SERVICE BULLETIN

N° **139-444**

REV. : C - June 28, 2018

ATA 78 - EXHAUST DUCTS AND REAR FIREWALL RETROMOD

Figure 29

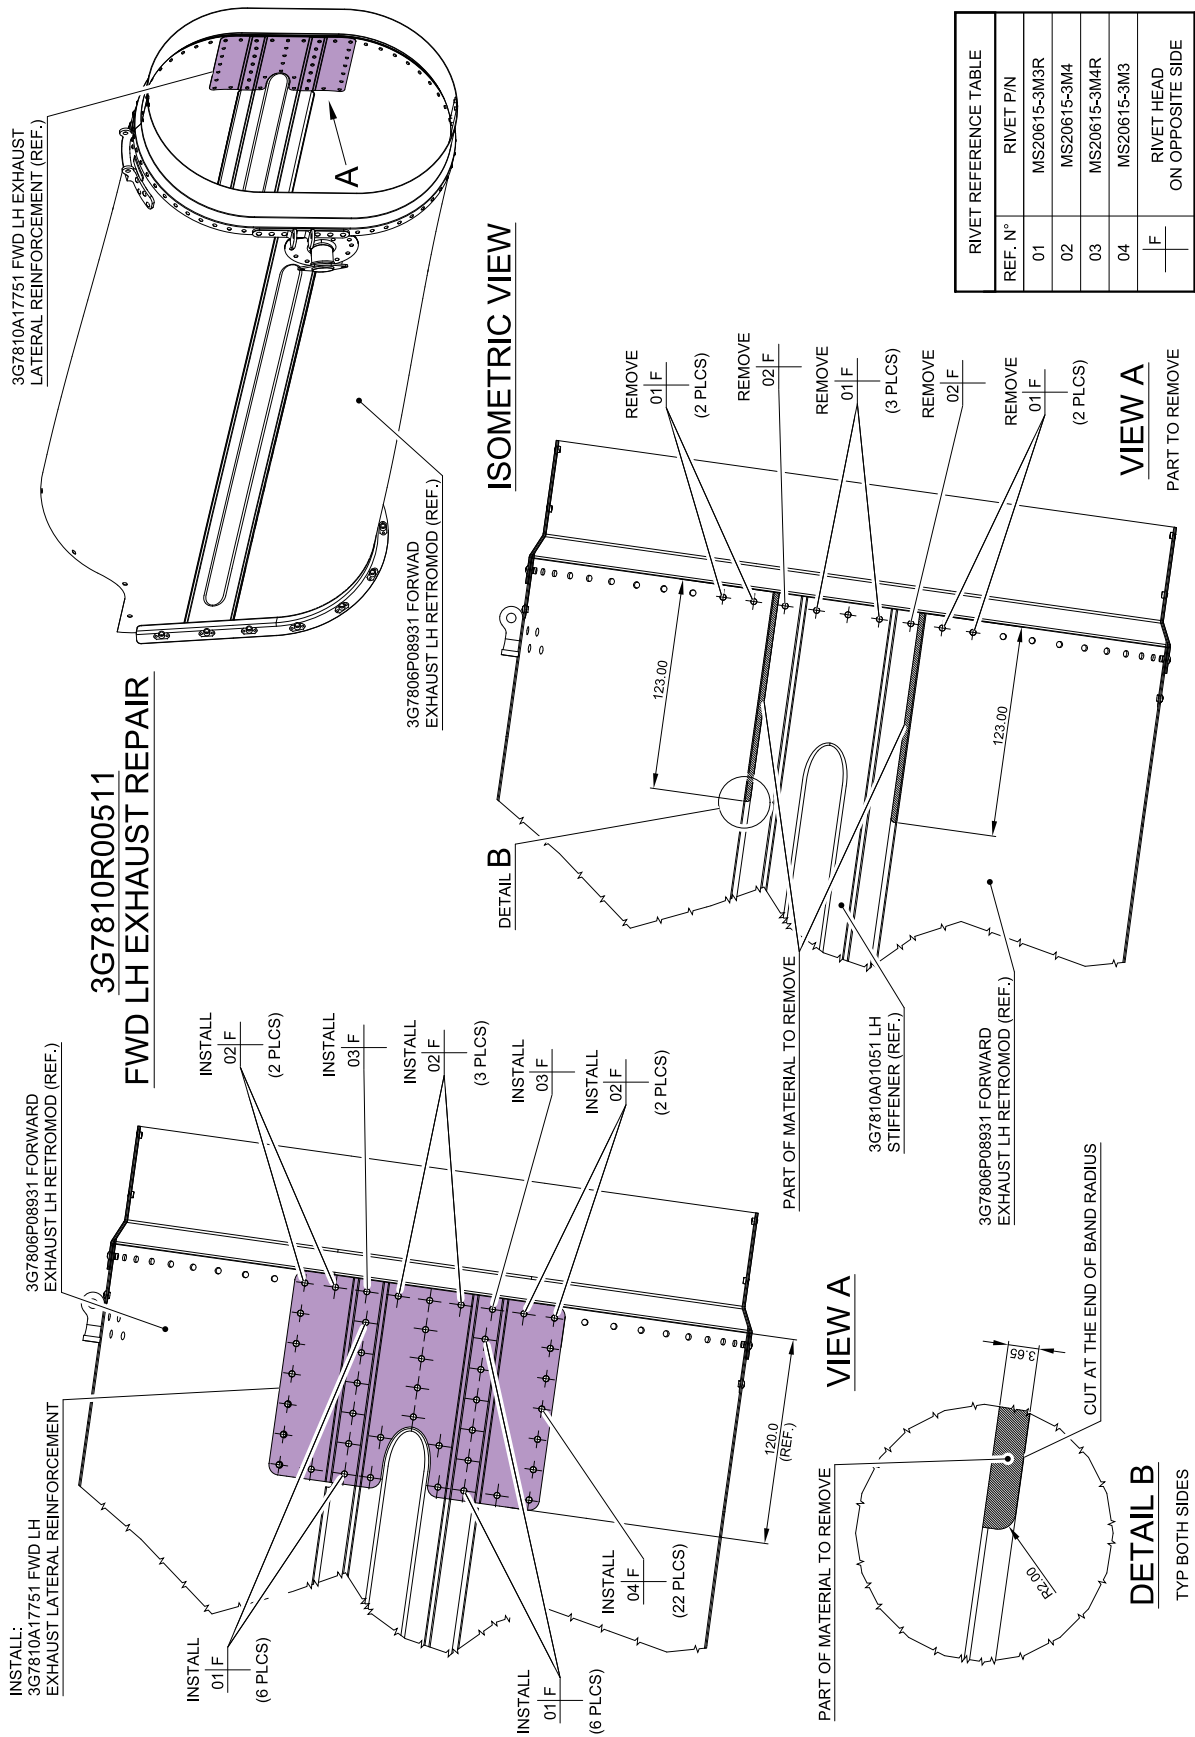
3. With reference to Figure 29, perform the forward left exhaust repair P/N 3G7810R00511, as described in the following procedure:
 - 3.1 With reference to Figure 29 view A, drill out the indicated existing rivets from the forward exhaust LH.

- 3.2 With reference to Figure 29 view A and detail B, rework and remove the indicated parts of material from the LH stiffener P/N 3G7810A01051.
 - 3.3 With reference to Figure 29 view A, temporarily locate the FWD LH exhaust lateral reinforcement P/N 3G7810A17751 inside the forward exhaust LH.

- 3.6 With reference to Figure 29 view A, drill n°43 rivet holes $\varnothing 2.36 \div 2.62$ in the previously marked positions.
 - 3.7 With reference to Figure 29 view A, install the FWD LH exhaust lateral reinforcement P/N 3G7810A17751 by means of n°22 rivets P/N MS20615-3M3, n°12 rivets P/N MS20615-3M3R, n°7 rivets P/N MS20615-3M4 and n°2 rivets P/N MS20615-3M4R.

Figure 31

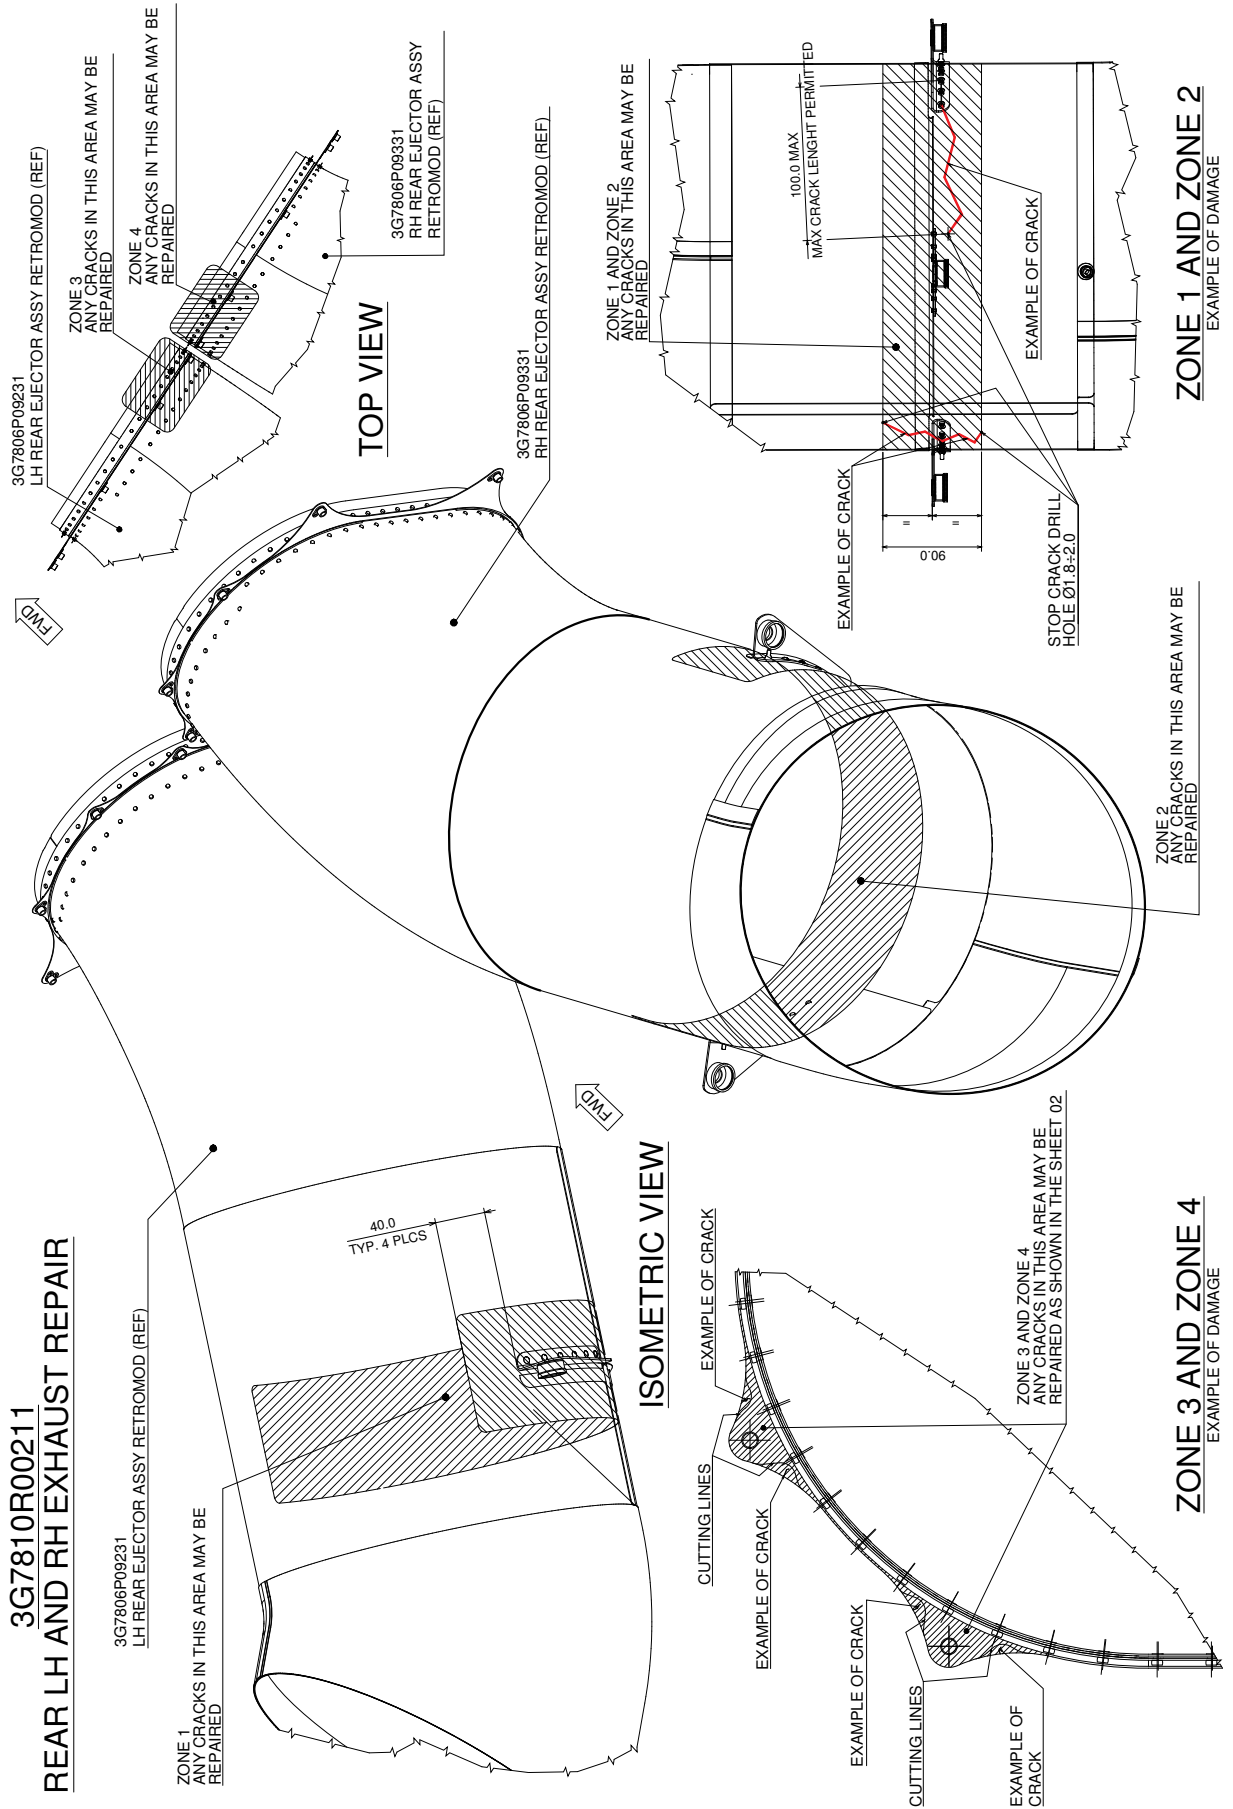
2. With reference to Figure 31, verify if cracks are in the areas and within the maximum dimension permitted.

2. With reference to Figure 31, verify if cracks are in the areas and within the maximum dimension permitted.

Figure 34

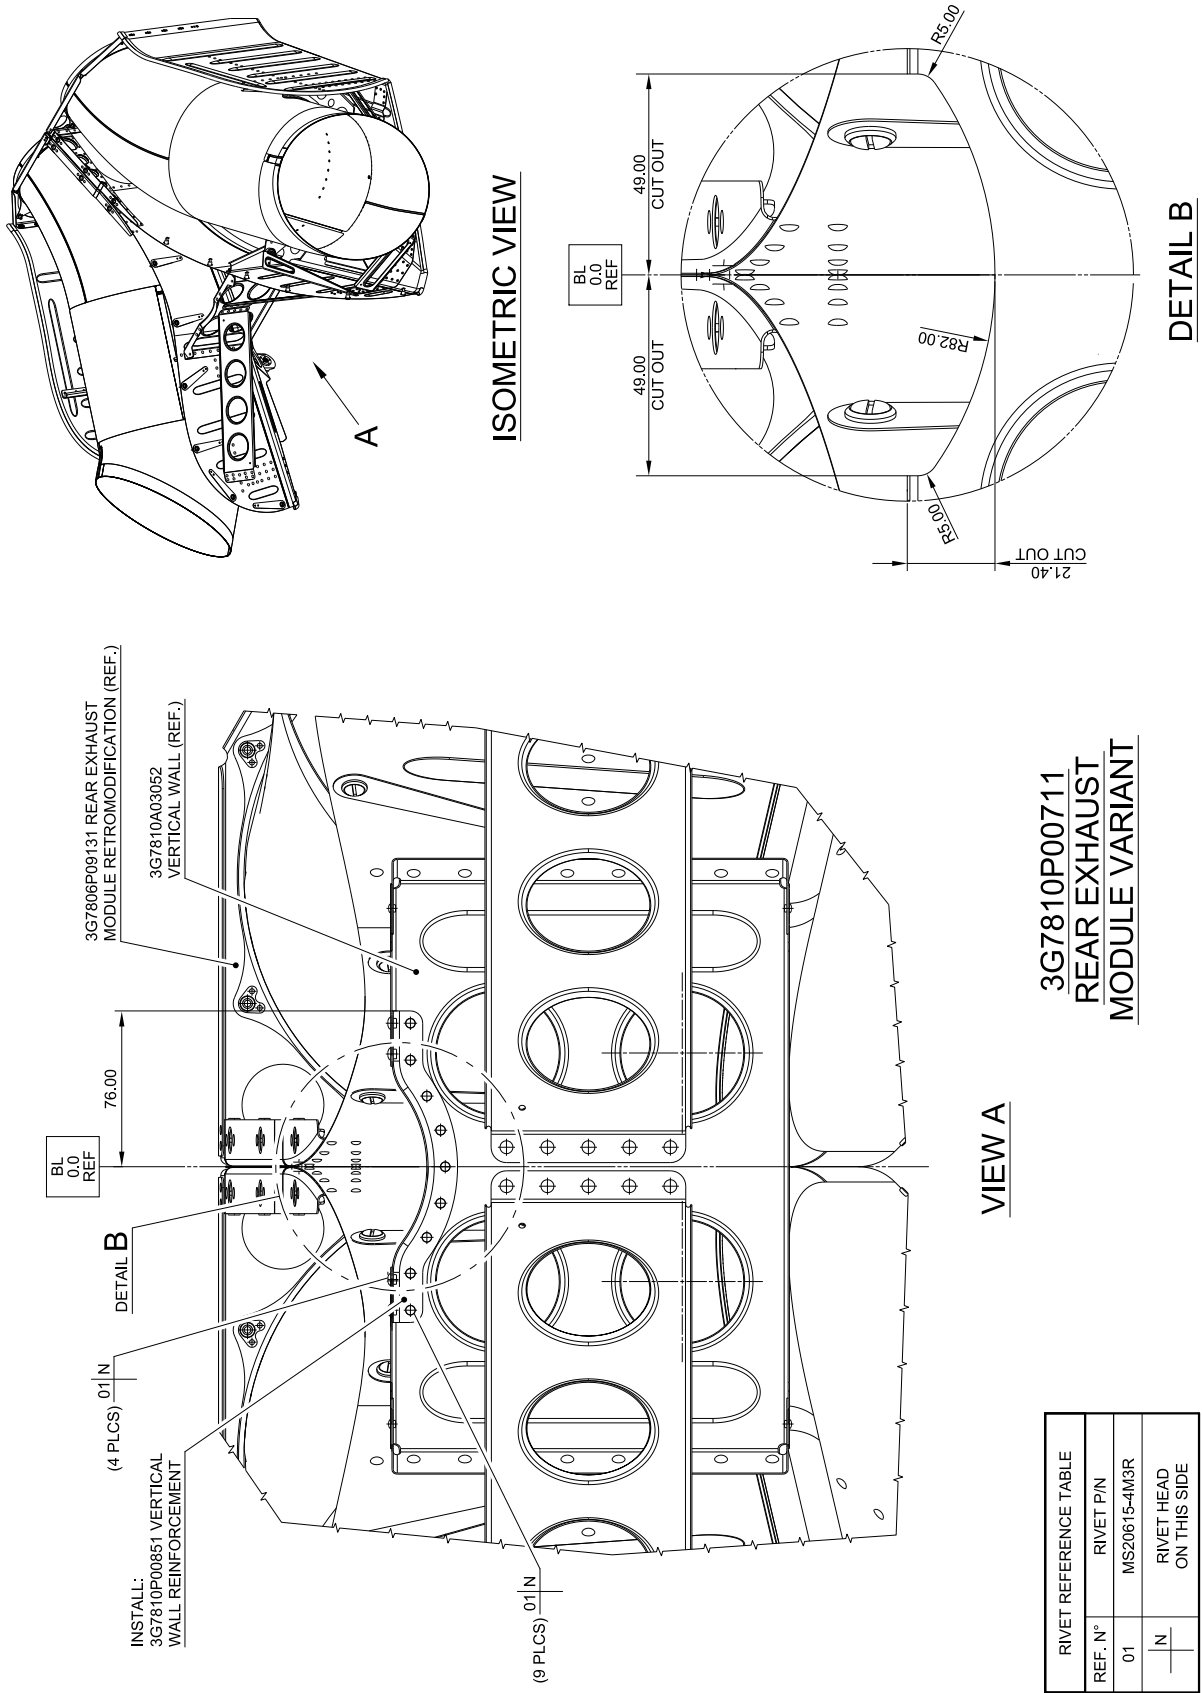
- 2.38 With reference to Figure 34, perform the Talon antenna variant P/N 3G7810P00711, as described in the following procedure:
- 2.38.1 With reference to Figure 34 detail B, perform n°1 cut out with shape and dimension shown on the vertical wall P/N 3G7810A03052.
- 2.38.2 With reference to Figure 34 view A, install n°1 vertical wall reinforcement P/N 3G7810P00851 by means of n°13 rivets P/N MS20615-4M3R.
3. Send the attached compliance form to the following mail box:
- cse.aw139.aw@leonardocompany.com

Figure 35

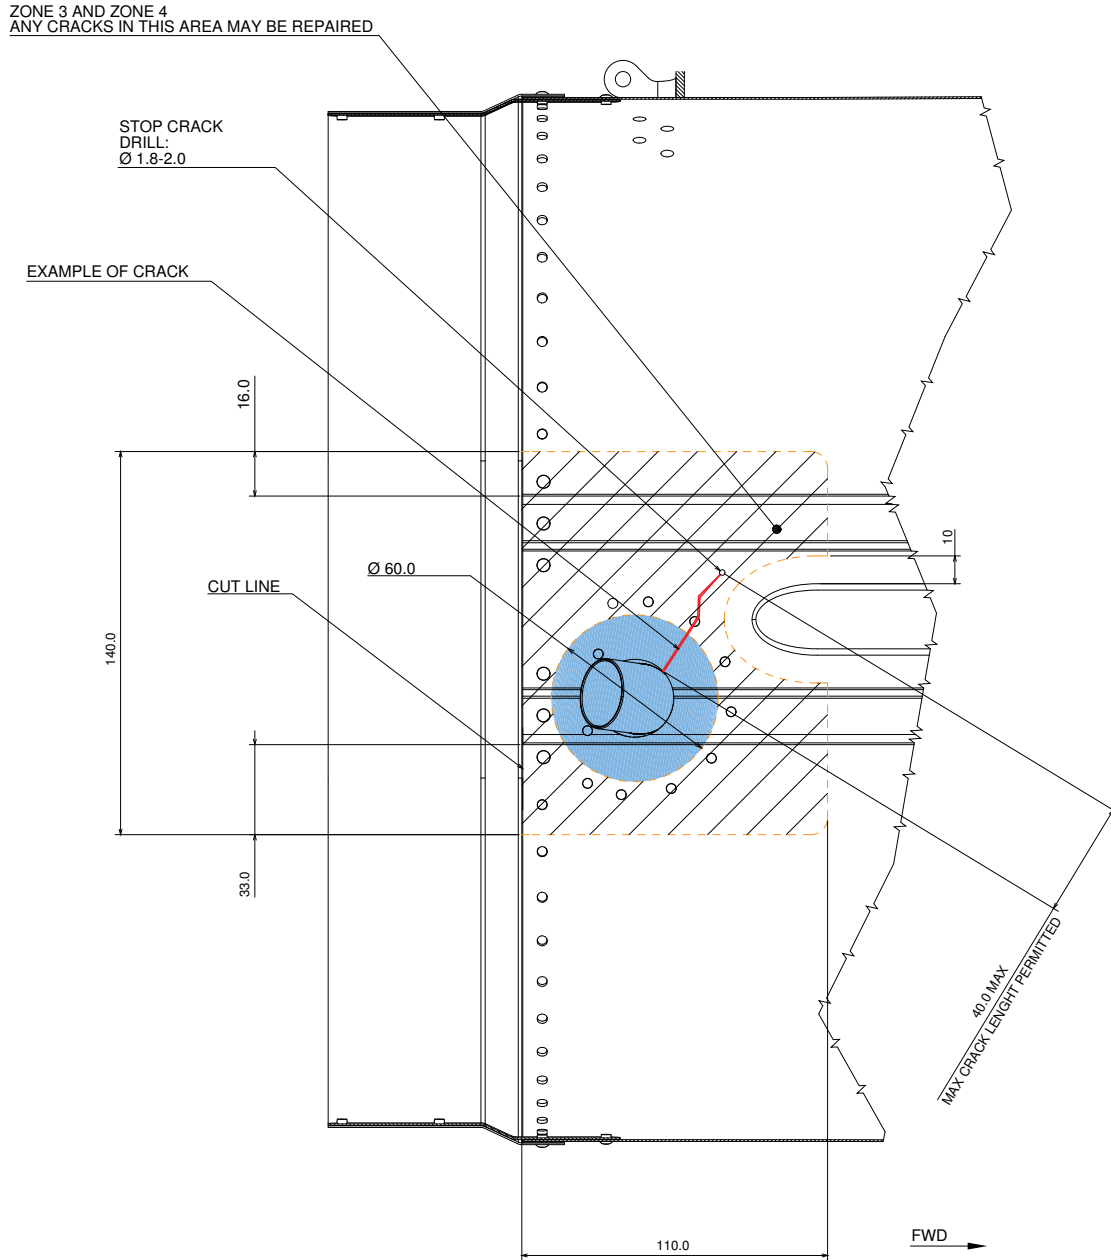
In the Zone 3 is acceptable to have multiple cracks or lack of material in the circular area highlighted in Figure 35.

In the Zone 4 is acceptable to have multiple cracks or lack of material in the circular area highlighted in Figure 35.

Figure 36

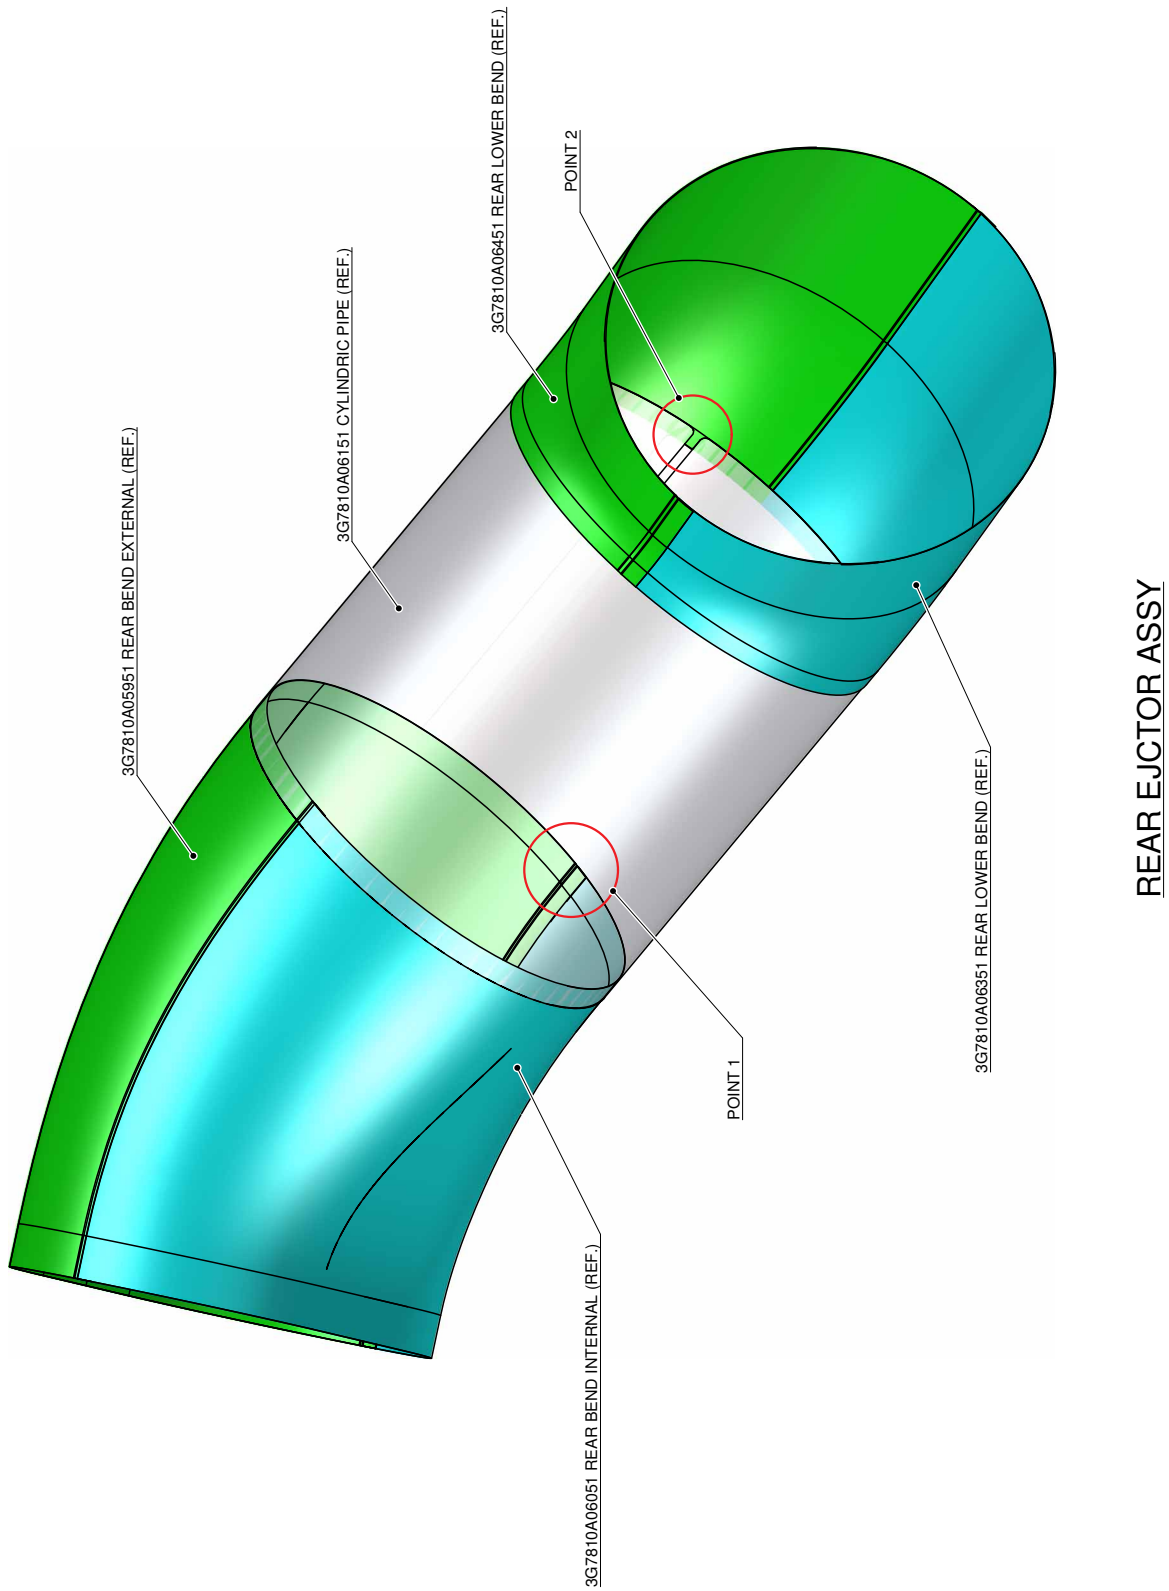
- g) With reference to Figure 36, if a slot is observed on the junctions (Point 1 and 2) between the cylindrical pipe and the others metal sheets of the rear exhaust P/N 3G7810A02131 or 3G7810A02231 or 3G7806P09231 or 3G7806P09331, it is possible to plug it by means of inert gas tungsten arc welding according to AWS D17 Class B (for complete duct sealing).

Figure 37

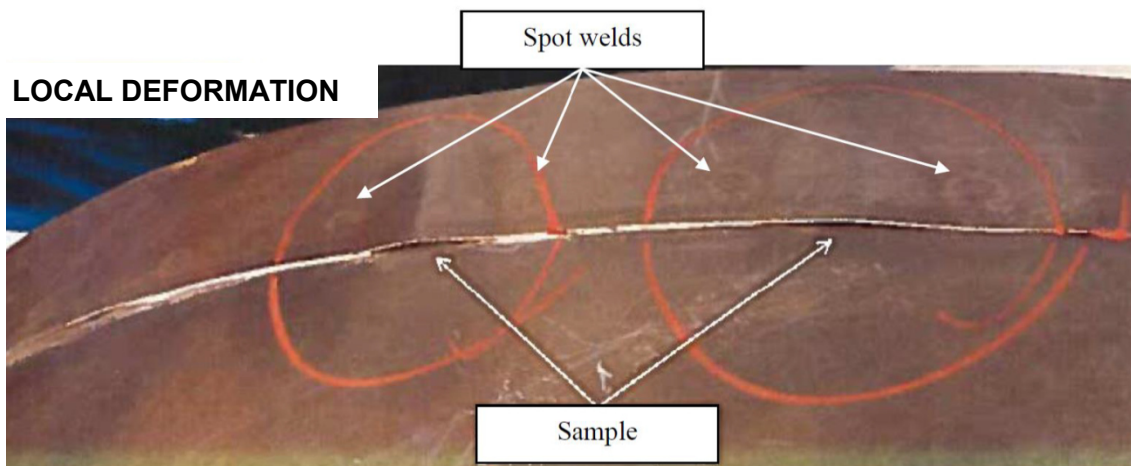
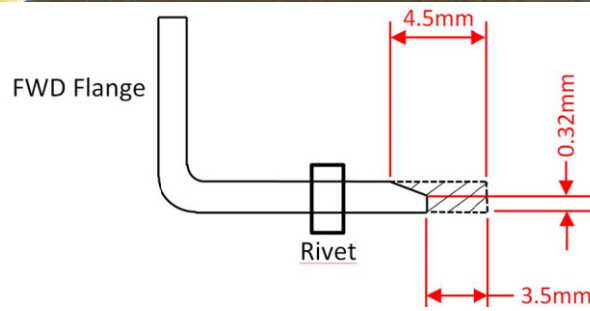
- 4.1 Comply with Part XII of this SB to install Rear LH exhaust repair P/N 3G7810R00611.
 - 4.2 With reference to Figure 37, verify if the holes lies inside the reinforcing plates are at least 10mm from the plates edges.

5. If the Rear Exhaust FWD Profile P/N 3G7810A06651 or P/N 3G7810A06751 has wear perform the following operation:
 - 5.1 With reference to Figure 37, verify the maximum extension and depth of residual damage. Any residual damage that affects the dashed area indicated in Figure 37, is considered acceptable; if the damage exceeds the dashed area, contact AW139 Customer Support Engineering (cse.aw139.aw@leonardocompany.com) to receive proper repair instruction.

6. With reference to Figure 37, verify the presence of a local deformation of the reinforcing ring on the end section of the Rear Exhaust.
 - 6.1 If such deformation is confined within two consecutive spot welds without affecting their adherence to the exhaust duct, and its height do not exceeds 1mm, then it is acceptable. If NOT, contact AW139 Customer Support Engineering (cse.aw139.aw@leonardocompany.com) to receive proper repair

- 4.1 Comply with Part XIII of this SB to install Rear LH exhaust repair P/N 3G7810R00612.
 - 4.2 With reference to Figure 37, verify if the holes lies inside the reinforcing plates are at least 10mm from the plates edges.

5. If the Rear Exhaust FWD Profile P/N 3G7810A06651 or P/N 3G7810A06751 has wear perform the following operation:
 - 5.1 With reference to Figure 37, verify the maximum extension and depth of residual damage. Any residual damage that affects the dashed area indicated in Figure 37, is considered acceptable; if the damage exceeds the dashed area, contact AW139 Customer Support Engineering (cse.aw139.aw@leonardocompany.com) to receive proper repair instruction.
